May 12, 2010
File: 02-0775-50-3939/Vol 01

Re: Addendum #1 3939Q – Hamilton Community Centre – Piling

JOB TITLE
**HAMILTON COMMUNITY CENTRE
 EXPANSION PROJECT**

SK-000
 Revision: 00

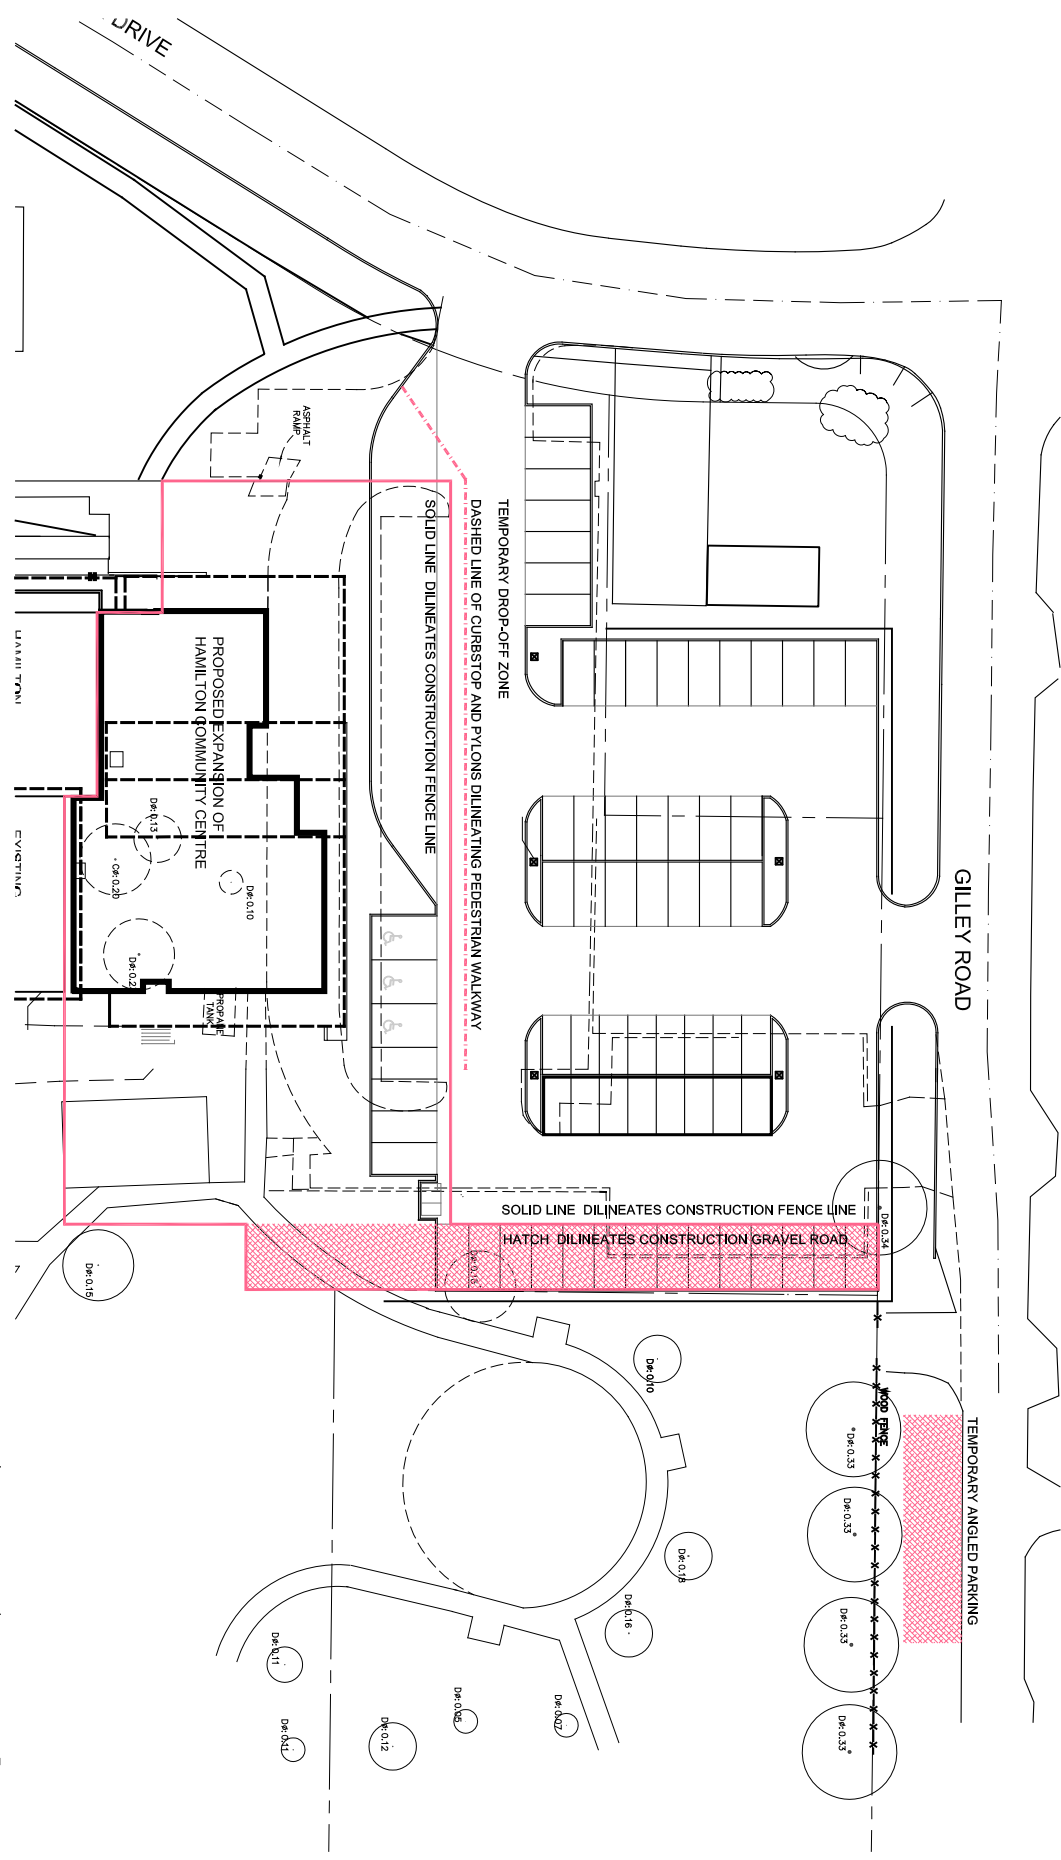
6. Site plan is as shown in SK-000, May 2, 2010. Contractor will be required to access the site from Gilley Road by use of the construction gravel road and work within the construction fence line as shown. Please see attached drawing "Site Plan Construction Hoarding Plan".
